Minor amendment to the prior approved site plan for and outdoor kitchen, retaining wall shift, ADA sidewalk revision, water meter relocation, and revision to sidewalk connection at row.

Overture Andalucia

Project Number: PR-2020-003658

The purpose of this letter is to request approval of a Minor Amendment to the Overture Andalucia Site Plan - DRB (PR-2020-003658) to allow for and outdoor kitchen space with metal shade cover at the pool at courtyard, a shift in the south retaining wall, the relocation of the water meter, a revised sidewalk connection to the Public ROW, and a revision to the garage ADA path. The subject site is under construction and located at 5301 Antequera Road NW and is legally described as Lot 4-A Plat of Tract 4-A North Andalucia at La Luz and is approximately 8 acres in size.

AASP1 Site Plan -
Approved 06/15/2021

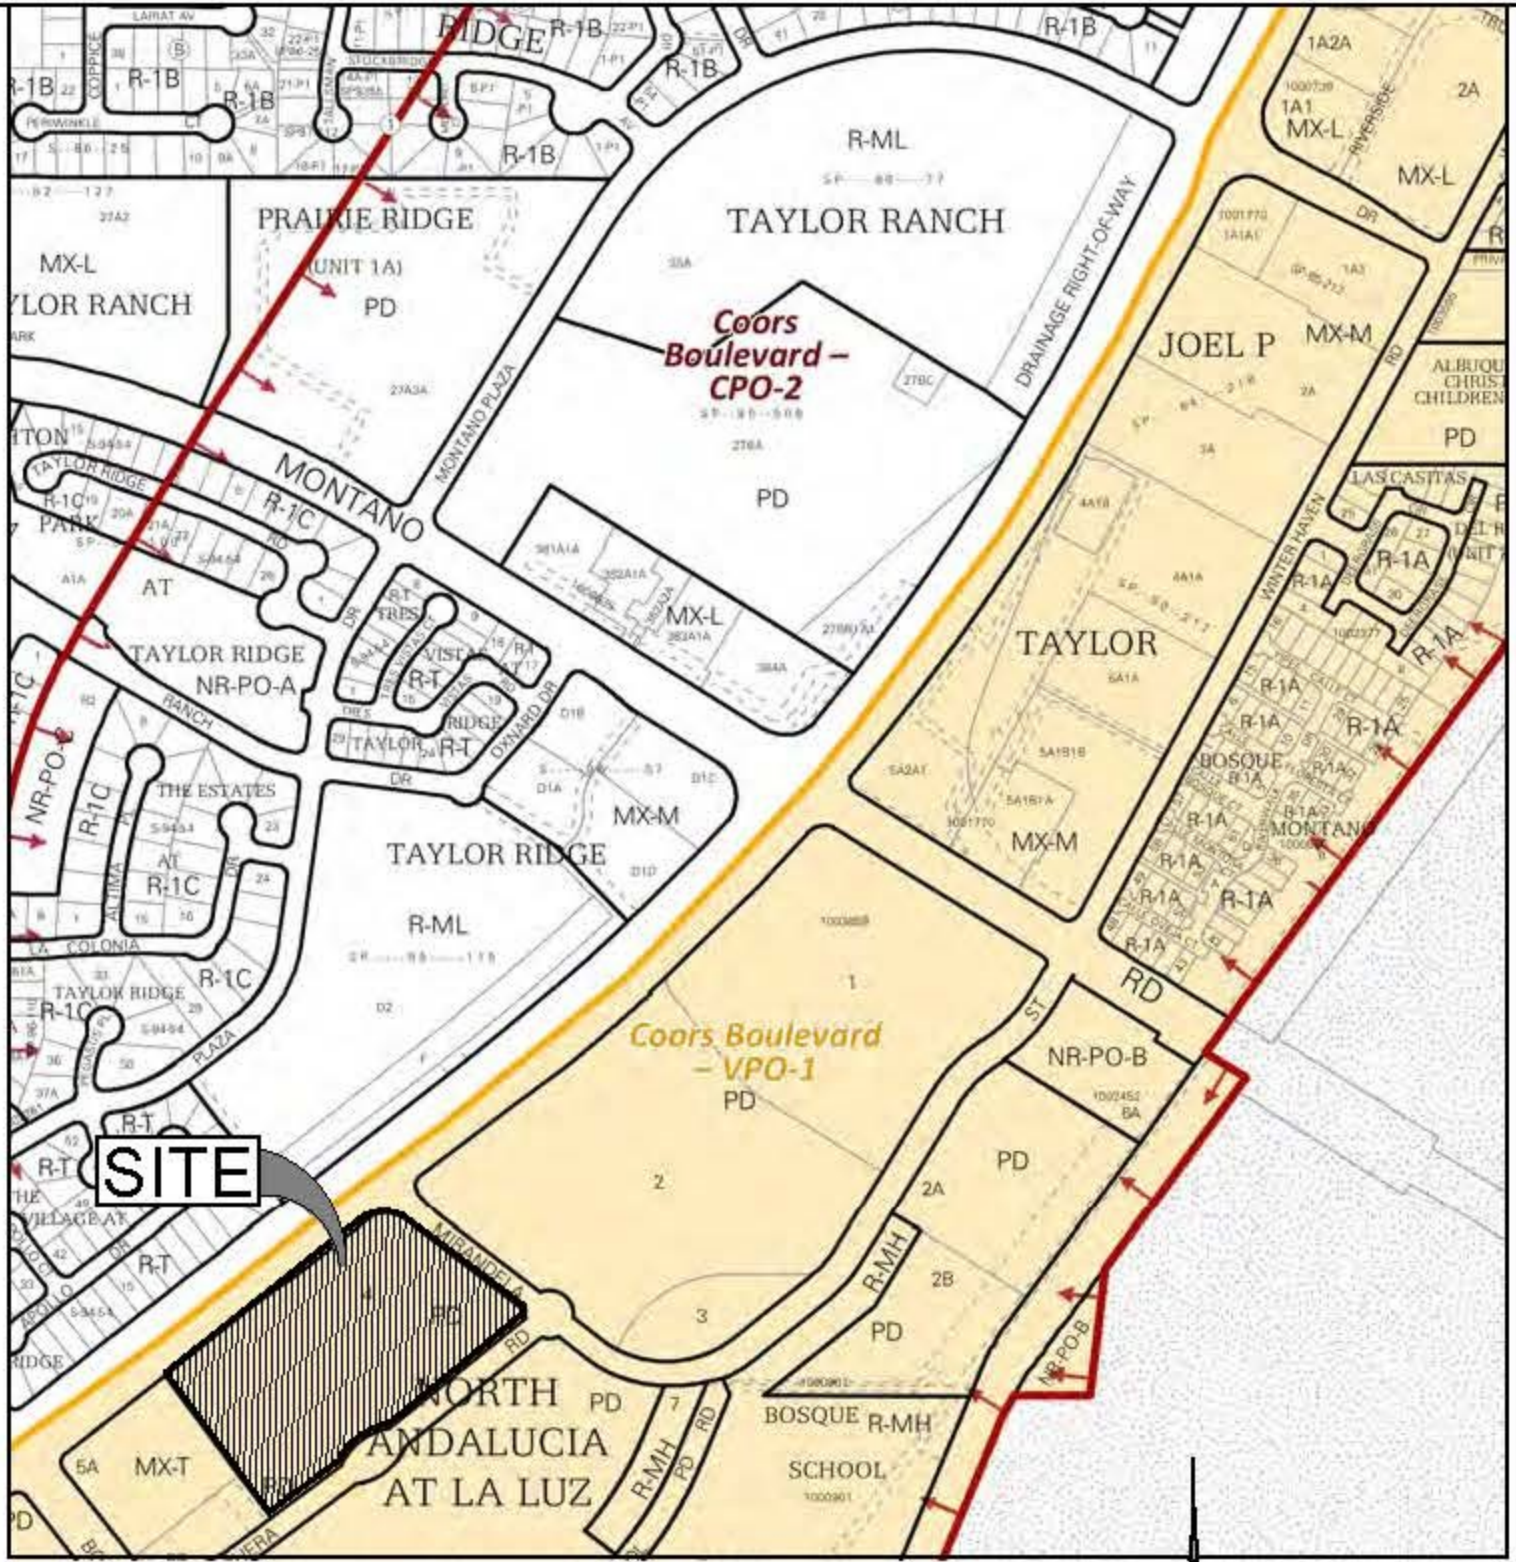
Modification of building elevations for cottage duplex units (removal of stone veneer from exterior wall base);

Minor modifications to windows and awnings on the primary building (to accommodate roof drainage requirements with downspouts)

1 SITE PLAN

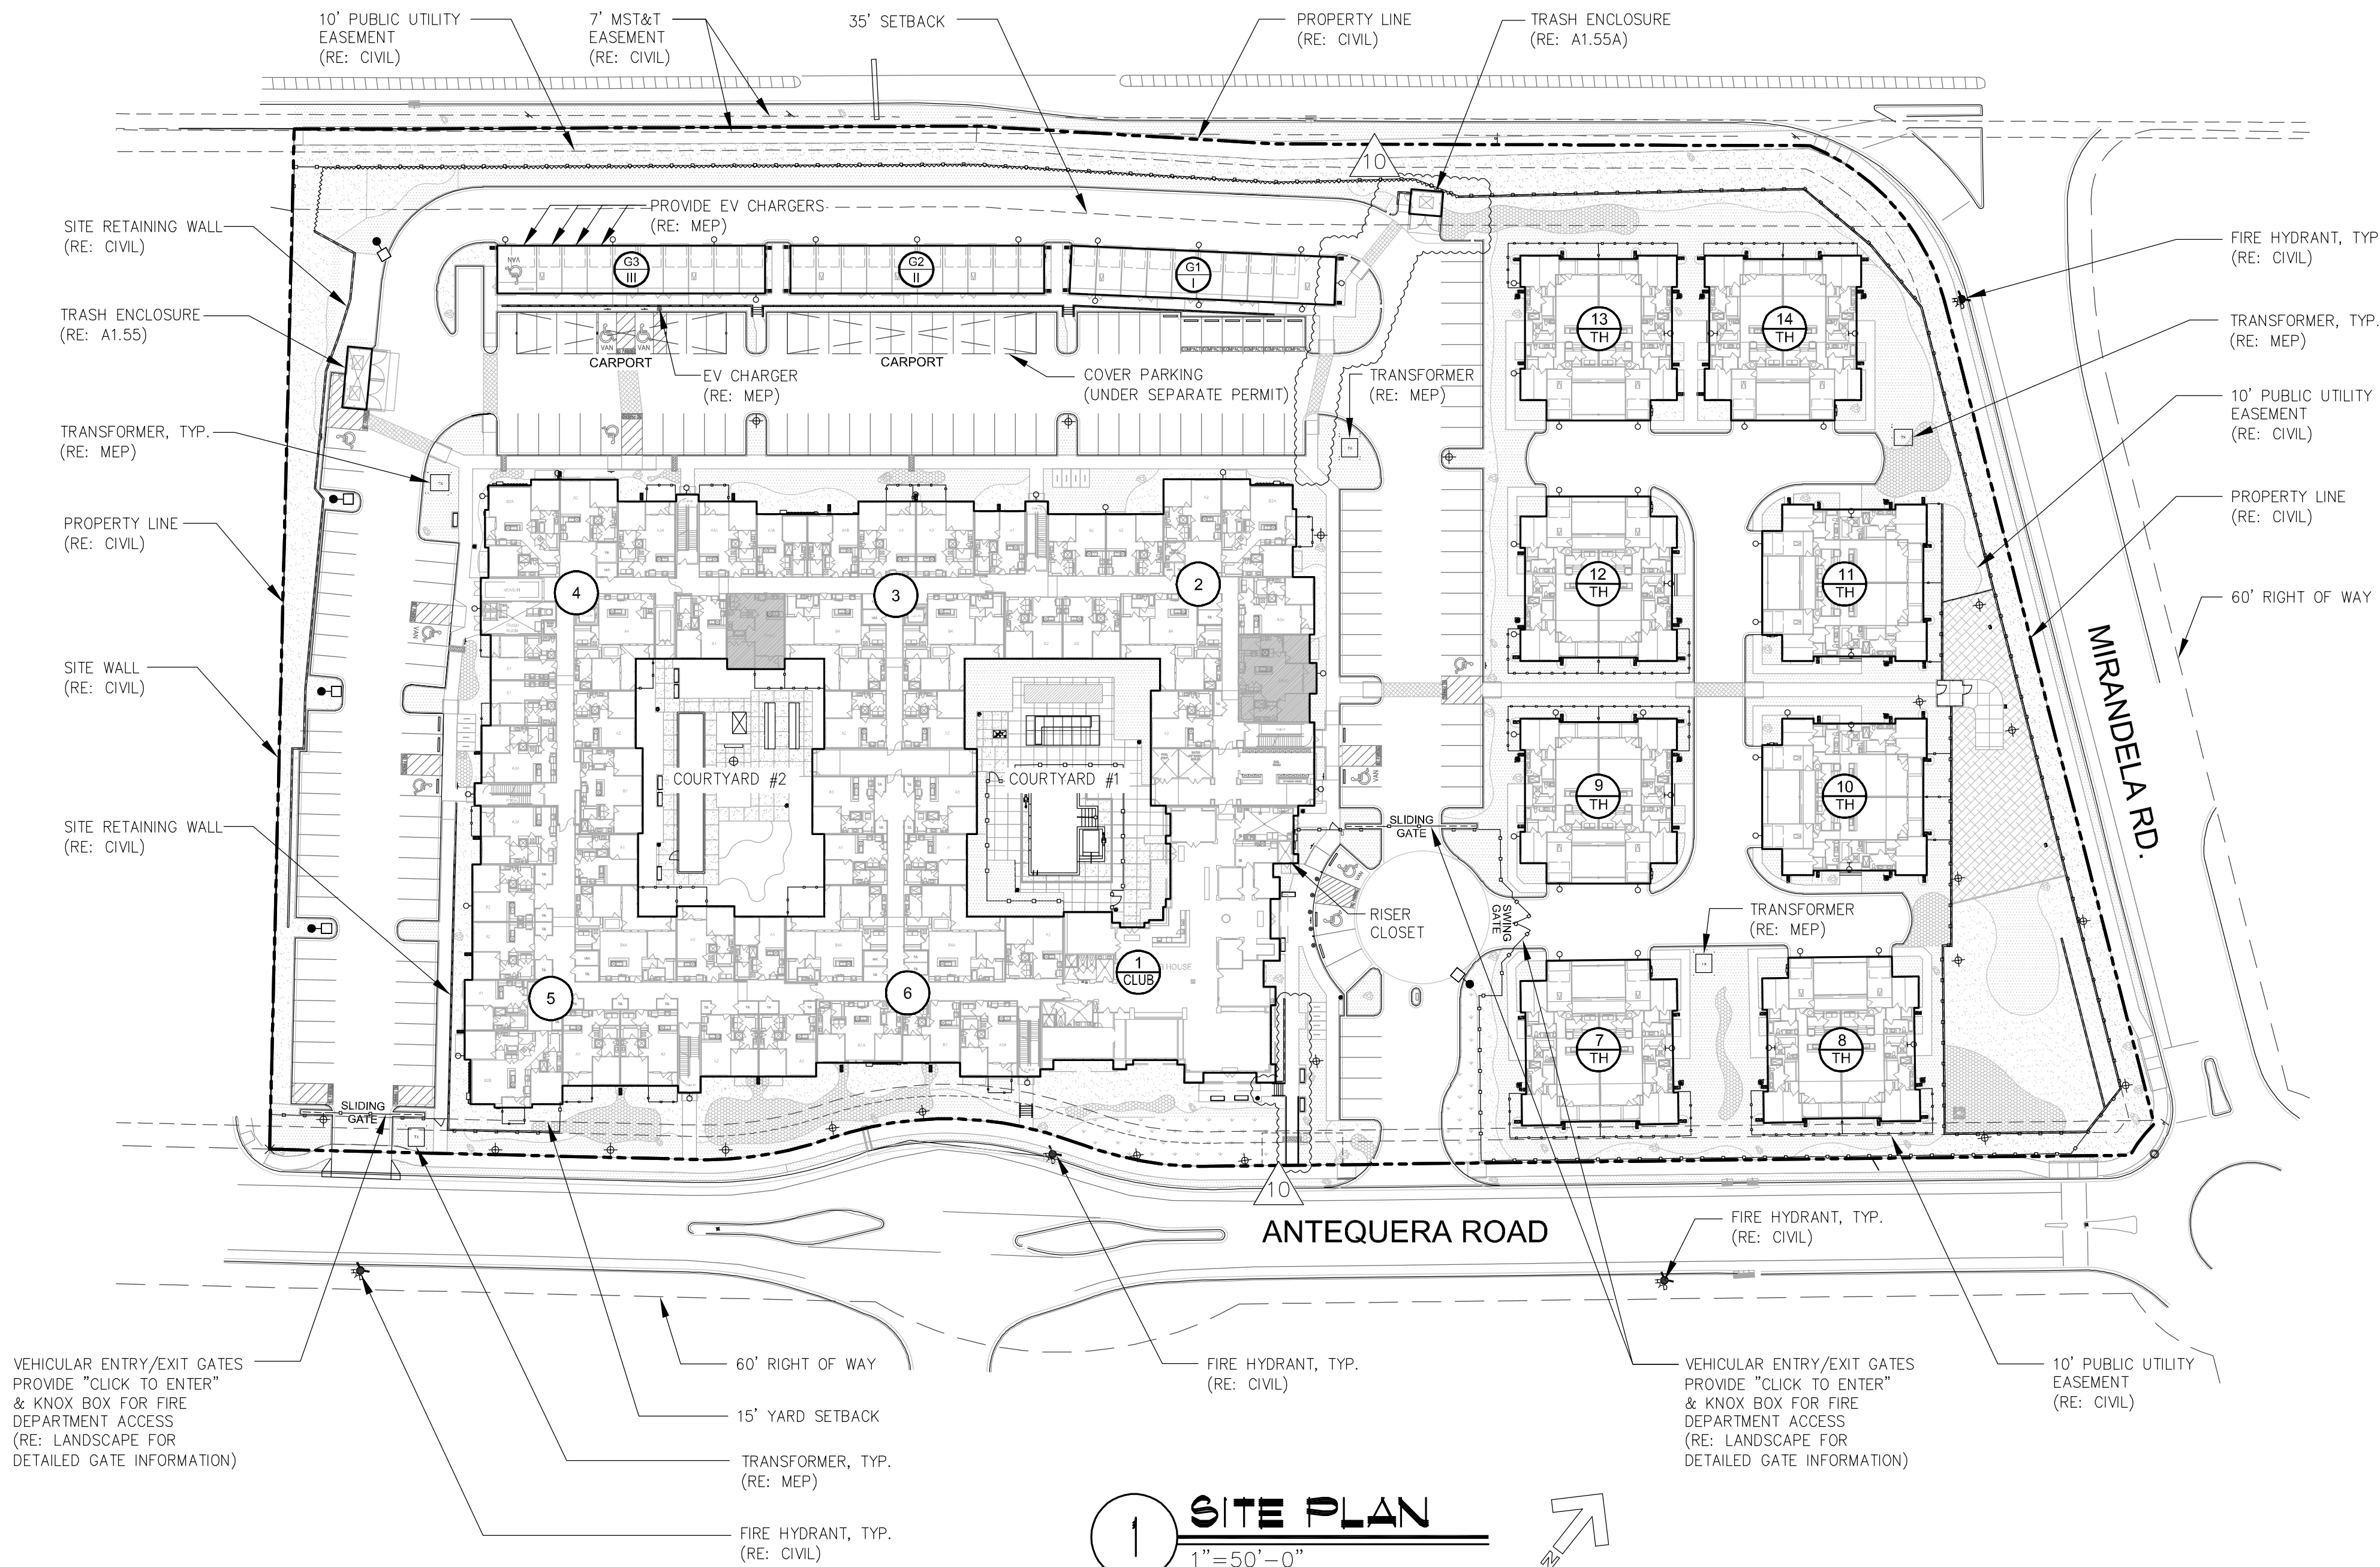
Amendment to add an additional residential recycling receptacle; Addition of (2)

additional carports. Carports meet setback requirements of the original Site Plan

approval for the development.

SITE PLAN

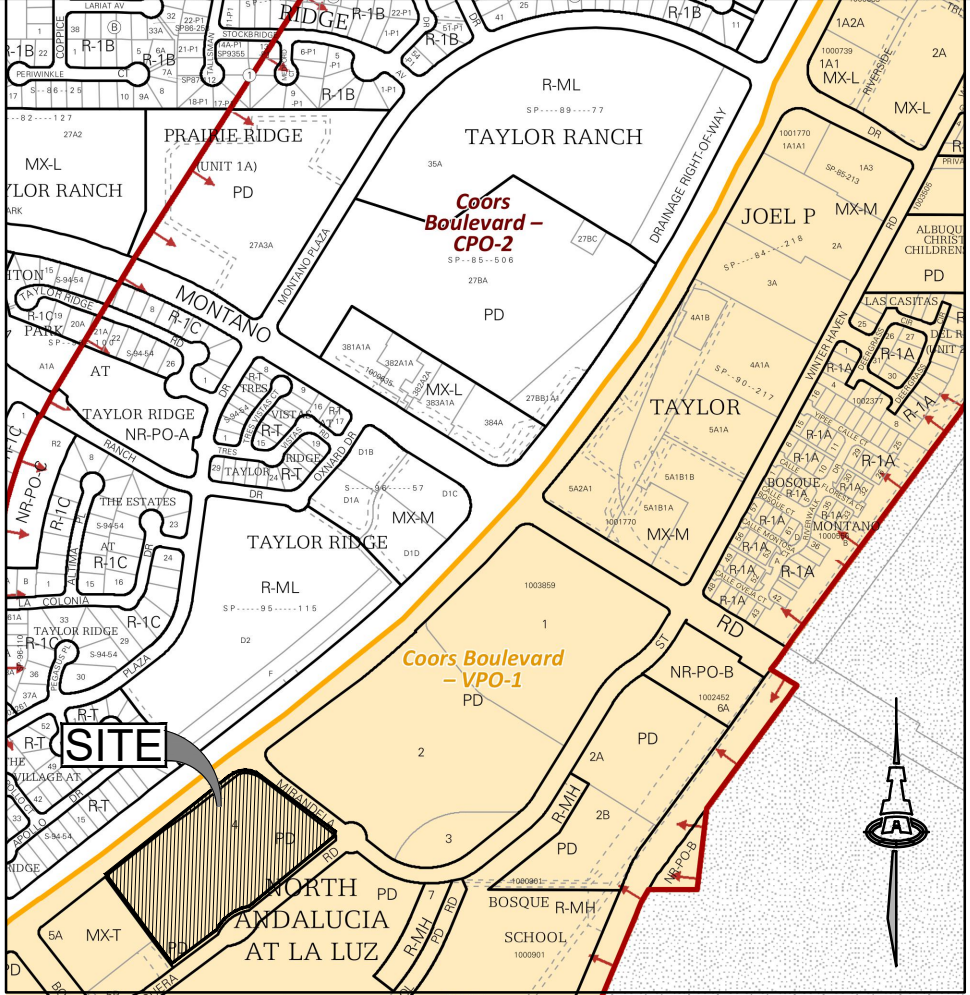
The retaining wall shift at the south side of the project was due to unforeseen conditions in the field. The wall was shifted towards the interior of the site to avoid impacting the neighbor's wall footing. No amount of the retaining wall was shifted on to the neighbor's property or impacted the designated setbacks. The shift in the wall caused 4 of the standard parking stalls being converted to compact parking stalls. This shift in parking has not impacted our ability to provide the required amount of parking stalls, in fact the project is still providing more than the required number or parking stalls. The shift in the retaining wall provides additional security that the product was built

The Water Meter location was shifted during the PWO review process. This change was made at the request of the Water Authority and does not impact the residents. At the time of the original site plan it was not noted that this relocation was needed.

The sidewalk connection to the ROW had handrails added to ensure residents have the highest level of safety for this area. At the time of the original site plan it was not noted that handrails were necessary at this location.

The ADA path at the garage was removed from the Site plan. This was a drawing discrepancy and should not have been noted on the prior Site Plan versions. There is no reduction in the amount of ADA walkways and the change does not impact or violate ADA requirements.

- MINI CLEAR SIGHT TRIANGLE, SEE GENERAL NOTE #5 THIS SHEET
- ROUNDABOUT INTERSECTION SIGHT DISTANCE, SEE GENERAL NOTE #5 THIS SHEET
- COURTYARD OUTDOOR KITCHEN W/ STEEL SHADE STRUCTURE
